TECHNICAL SERVICE BULLETIN

TSB#: 16-009 Job Code: 9801288 Flat Rate: .4 hr

Add steel plug to furnace to ensure proper operation.

2016 Jay Feather Feather X23B G1JB 0301-0303, 0308,0311-0312, 0314-0316, 0321-0324,0328-0329,
0332, 0344, 0367

FIG 1

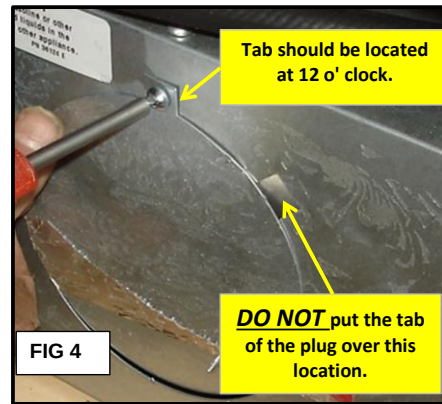
- 1 Fig 1: Wood Vent below the refrigerator - Remove the 4 screws
Fig 2: Gently pull the wood vent out to access the furnace.
